THE MARYLAND-NATIONAL CAPITAL PARK AND PLANNING COMMISSION

**MEMORANDUM**

**PROJECT NAME:** Congressional Forest Estates

**CASE NO.** 1-03042

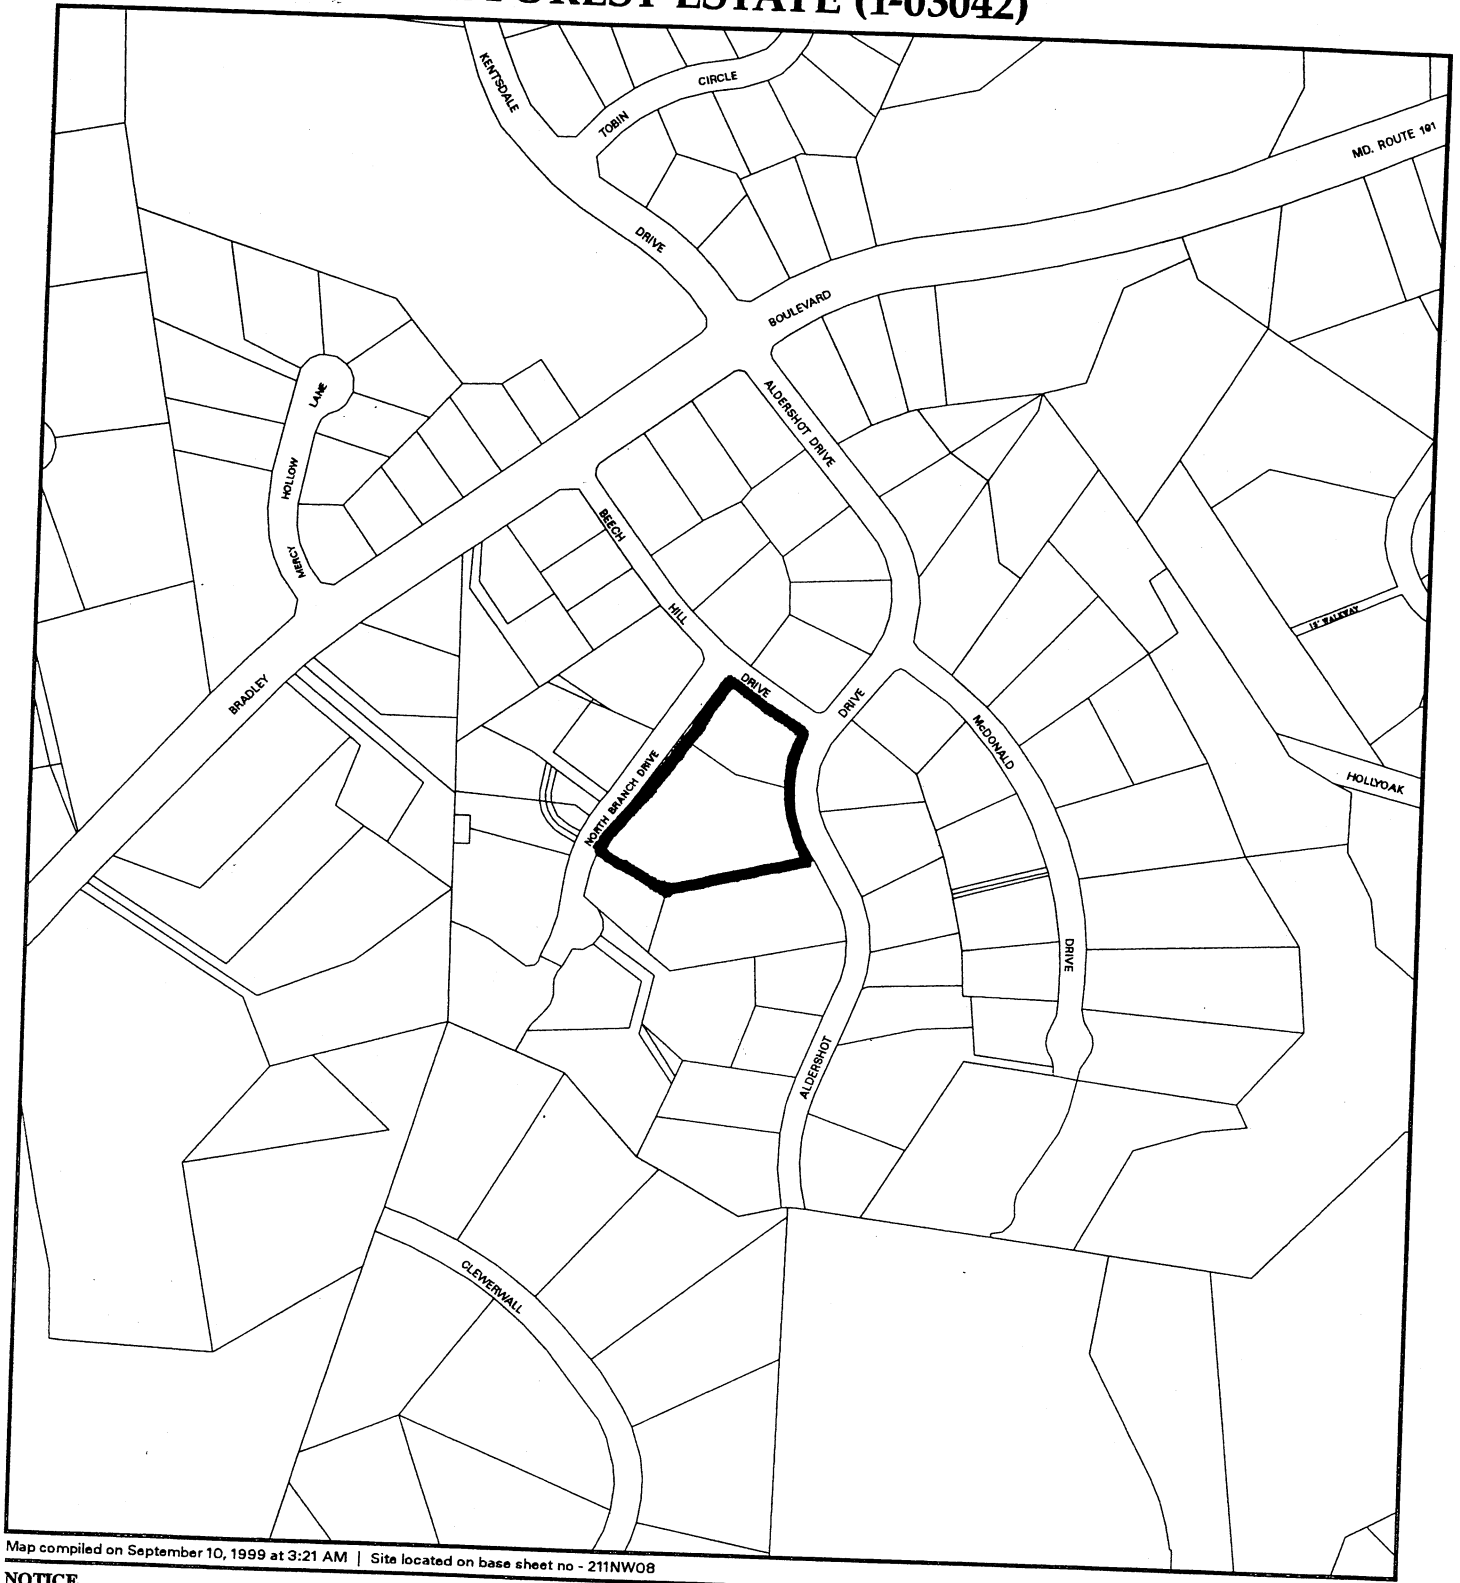
In applying the resubdivision criteria to the analysis area delineated by staff, staff concludes that the proposed resubdivision does not satisfy the criteria set forth in Section 50-29(b)(2) as illustrated by the characteristics set forth in the attached tabular summary. All but one of the proposed lot sizes is considerably smaller than the lots found in the defined neighborhood. In fact the three lots proposed, Lots A, B, D and E are at the lower end of the lots sizes found in the staffs neighborhood delineation. These smaller lots sizes generally produce smaller building areas in which to locate the proposed dwellings.

Staff's concerns are rooted in the compatibility of the proposed lots with the general large lot character of the defined neighborhood. The five (5) lot proposal, in staff's estimation, is out of character with the existing development pattern displayed along the neighboring streets. The site also contains many mature and significant trees that warrant an effort to save as many as possible. By reducing the number of lots to four (4), i.e. eliminating the lot fronting on Beech Hill Drive, Lot A, houses on the other portion of the property could be spread out avoiding areas where significant trees are clustered. Staff is willing to work with the applicant and their representatives in developing a tree preservation plan that is sensitive and acceptable to all parties.

It should be reiterated that the Planning Board must find that the proposed resubdivision substantially meets *all* of the resubdivision criteria found in Section 50-29(b)(2). Staff finds that this application for five (5) lots fails to satisfy the characteristics of size and area and finds that a four (4) lot plan would be more compatible in size and area when compared to the other lots found in the defined neighborhood.

**STAFF RECOMMENDATION:** Approval of Four (4) Lots Only Pursuant to Section 50-29 (b)(2) of the Subdivision Regulations, Subject to the Following Conditions:

- (1) Submit a revised preliminary plan and revised forest conservation plan depicting four (4) single family detached dwelling units. Plans must include final house location, final site grading and priority tree preservation areas. Final forest conservation shall include tree preservation measures that are to be taken prior to, during and after construction phases
